RE: MACEDON RANGES SHIRE COUNCIL – DRAFT ROMSEY STRUCTURE PLAN – PUBLIC CONSULTATION

Draft Romsey Structure Plan (June 2023) Submission

Figure 3 Excerpt from Romsey Structure Plan

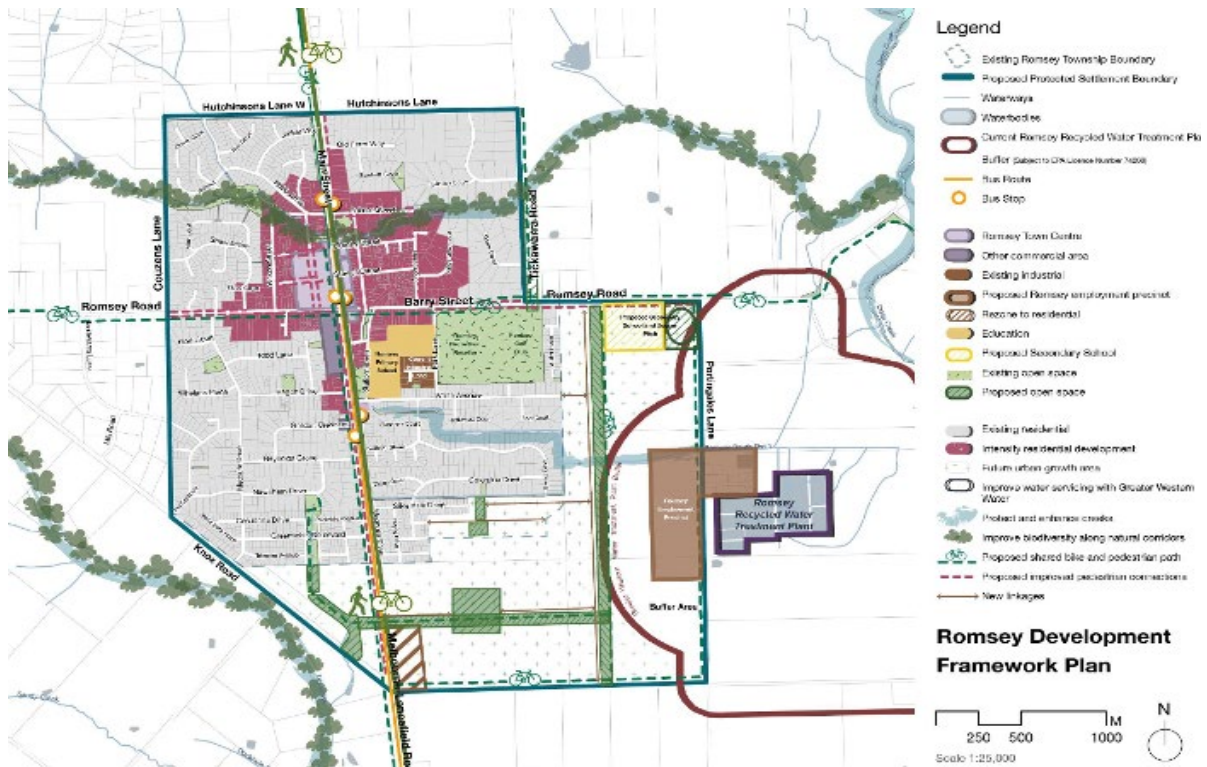
The proposed Romsey Township Framework Plan (the Framework Plan) indicates that the eastern Protected Settlement Boundary (PSB) will align with Portingales Lane, immediately outside the RRWP (although it will also incapsulate the Industrial 3 Zone land on the east of Portingales Lane).

As shown on the Framework Plan, the 'Current Romsey Recycled Water Treatment Plant Buffer (subject to EPA Licence No. 74268)' sits to the west of the proposed PSB. The overlap between the two areas may create issues.

There is a risk in Council progressing with the Structure Plan in the absence of this information, as the areas east and south of the township may ultimately find their opportunities curtailed by a new BAO. Moreover, the actual delineation of the buffer (and in particular the location of potential residential land uses) may also need to be modified depending on the results of this analysis.

Notwithstanding any potential change to the buffer designation, GWW is concerned about both the proposed secondary school (specifically the area of active open space to the east of the township) and the proposed Romsey Employment Precinct encroaching into the existing buffer.

The school would constitute a sensitive use and it is one where people (both staff and students) spend a considerable amount of time (including on the sporting ovals). Staff and students using the oval are likely to be subject to odour emissions from the RRWP, which they are likely to deem unacceptable. The school and its outdoor space should be moved entirely outside the existing designated buffer.

In terms of the Romsey Employment Precinct, from the Proposed Romsey Zoning Changes map included in the Structure Plan, this area is intended to be rezoned Industrial 1 Zone (IN1Z). This zone facilitate uses which could be sensitive to odours produced by the RRWP. While the commercial processes associated with industrial land use themselves may well be compatible with the RRWP, it is the long-term occupation of the Precinct by workers which is of concern to GWW.
